適航指令發布單

民航局 AD 編號 AD number	CAA-2022-07-008	發布日期 Date issued	2022/7/19
適用之航空產品 Applied to (models, serial numbers or part numbers, as applicable)	Kawasaki BK117 series helicopters equipped with a Goodrich rescue hoist assembly having a Part Number (P/N) as listed in Table 2.1 of this AD.		
主旨摘要 Subject	Goodrich rescue hoist assembly - Inspection / Replacement		
<div style="display: flex; justify-content: space-between;"> <div style="width: 30%;"> 民航局 CAA <input type="checkbox"/> 本國產品 Native product <input type="checkbox"/> 其他個案 Other </div> <div style="width: 70%;"> 設計國民航主管機構 Original Authority <div style="display: flex; flex-wrap: wrap;"> <div style="width: 50%;"><input type="checkbox"/> FAA</div> <div style="width: 50%;"><input type="checkbox"/> Germany LBA</div> <div style="width: 50%;"><input type="checkbox"/> EASA</div> <div style="width: 50%;"><input type="checkbox"/> CAA-NL</div> <div style="width: 50%;"><input type="checkbox"/> Brazil</div> <div style="width: 50%;"><input type="checkbox"/> UK CAA</div> <div style="width: 50%;"><input type="checkbox"/> Transport Canada Civil Aviation</div> <div style="width: 50%;"><input checked="" type="checkbox"/> Japan CAB</div> <div sty

Figure 1

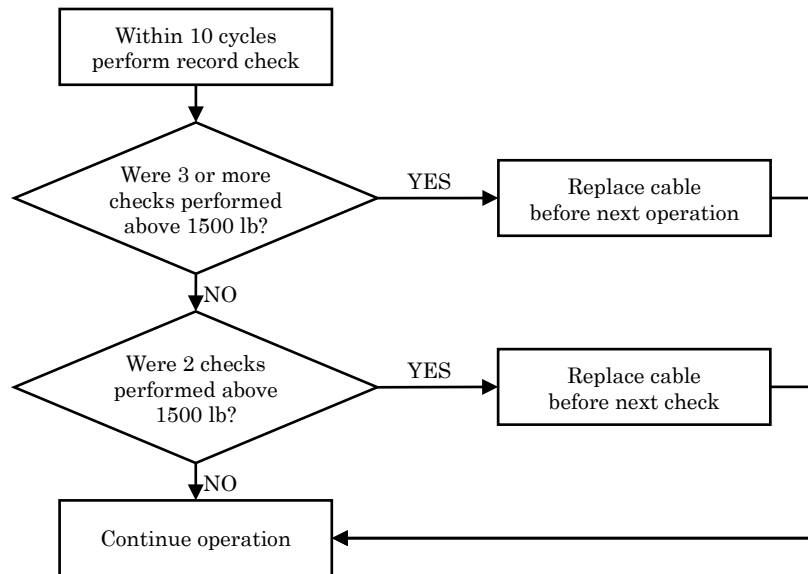
2.1 Within 10 hoist operating cycles from June 17, 2016 (the effective date of AD No. TCD-8201C-2016), accomplish a records check to determine whether, during any previous hoist load check/test, a cable was load-tested (average of 5 pulls) at 1500 lb [680 kg] or more. If any cable is identified to have exceeded this limit during two or more hoist load checks/tests, replace the affected cable with a serviceable cable within the time interval shown in paragraph 2.1.1 or 2.1.2 of this AD. For replacement of a cable, see Figure 1 of this AD.
